REGIONAL REVIEW NOTIFICATION

Name of Proposal: Collier Road Redevelopment

DEVELOPMENT OF REGIONAL IMPACT

| Preliminary Report: | March 12, 2007 | DEVELOPMENT OF REGIONAL IMPACT REVIEW REPORT | Project: | Collier Road Redevelopment #1311 |

V/C Ratios

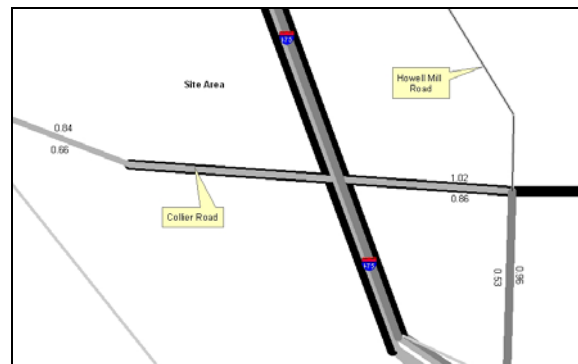
Projected traffic volumes from the Regional Travel Demand Model are compared to the assigned capacity of facilities within the study network. This data is used to calculate a volume to capacity (V/C) ratio. The V/C ratio values that define the LOS thresholds vary depending on factors such as the type of terrain traversed and the percent of the road where passing is prohibited. LOS A is free-flow traffic from 0 to 0.3, LOS B is decreased free-flow from 0.31 to 0.5, LOS C is limited mobility from 0.51 to 0.75, LOS D is restricted mobility from 0.76 to 0.9, LOS E is at or near capacity from 0.91 to 1.00, and LOS F is breakdown flow with a V/C ratio of 1.01 or above. As a V/C ratio reaches 0.8, congestion increases. The V/C ratios for traffic in various network years are presented in the following table. Any facilities that have a V/C ratio of 1.0 or above are considered congested.

For the V/C ratio graphic, the data is based on 2005, 2010 and 2030 A.M./P.M. peak volume data generated from ARC's travel demand model for Mobility 2030, the 2030 RTP and the FY 2006-2011 TIP, approved in March of 2006. The travel demand model incorporates lane addition improvements and updates to the network as appropriate. As the life of the RTP progresses, volume and/or V/C ratio data may appear inconsistent due to (1) effect of implementation of nearby new or expanded facilities or (2) impact of socio-economic data on facility types.
